# City of Sumter Design Review Board

June 26, 2025

## HP-25-10, 13 Bland Ave. (City)

<b>Applicant:</b>	Wilkes Builders, LLC
<b>Status of the Applicant:</b>	Authorized Agent for Property Owner
<b>Request:</b>	Design Review approval for construction of a new 2,300 sq. ft. raised slab single-family home with an attached garage.
<b>Location:</b>	13 Bland Ave.
<b>Present Use/Zoning:</b>	Undeveloped / Residential-9 (R-9)
<b>Tax Map Reference:</b>	228-09-02-079
<b>Adjacent Property Land Use and Zoning:</b>	North – Residential / Residential-9 (R-9) South – Residential / Residential-9 (R-9) East – Park / Residential-9 (R-9) West – Residential / Residential-9 (R-9)

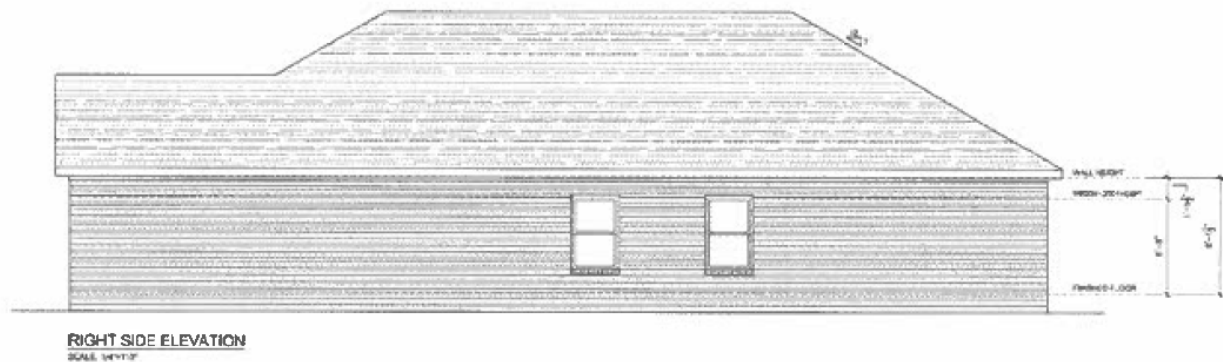
The **front elevation (above)** of the proposed structure utilizes a hip gable design with an open gable over the two-car garage. The front porch has two column supports. Proposed roofing material will be black architectural shingles. The proposed siding will be brick veneer.

The **right elevation (above)** will face an adjacent residence on Bland Ave. The design features two 1-over-1 windows massed in the center.

The proposed structure is a simple, straightforward design. The principal design element that the proposed structure proposes is a two-car garage which extends slightly beyond the covered front porch. This architectural feature results causes the style to be most commonly referred to as a “snout house”.

A snout house’s exterior design emphasizes what is typically the least attractive element of a house: the garage. Snout houses can convey the message that cars, not people, occupy the neighborhood. As a result, such developments are less friendly to pedestrians.

However, the proposed garage placement that makes the house a ‘snout house’ does distract from the porch as the focal point of the front façade (see analysis for Sections 6.2(a) and 6.2(b) on page 7 of this report).

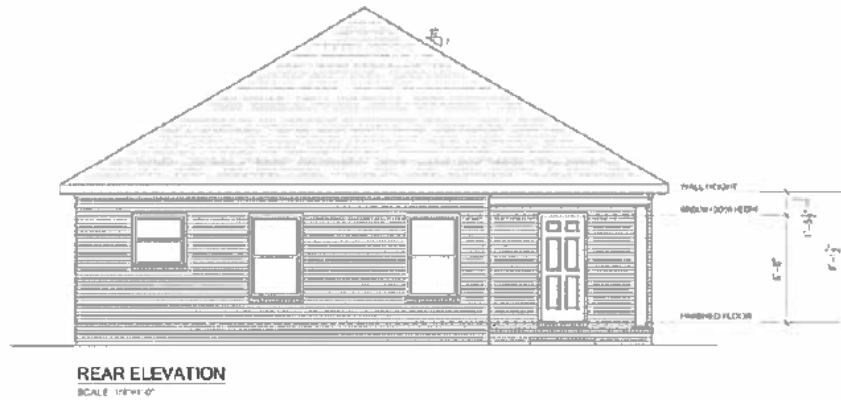
The **left elevation (above)** will face an adjacent residence on Bland Ave. It features three paired 1-over-1 windows and a smaller 1-over-1 window in the kitchen. This elevation also features a rear porch area at the corner of the structure.

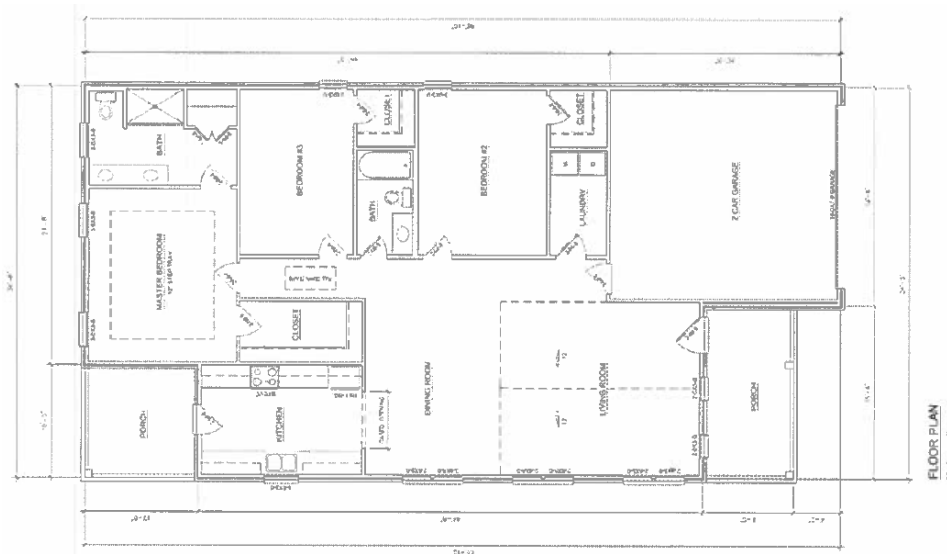
The **rear elevation (above)** incorporates a screen porch, a pair of 1-over-1 windows, and a smaller 1-over-1 window in the bathroom.
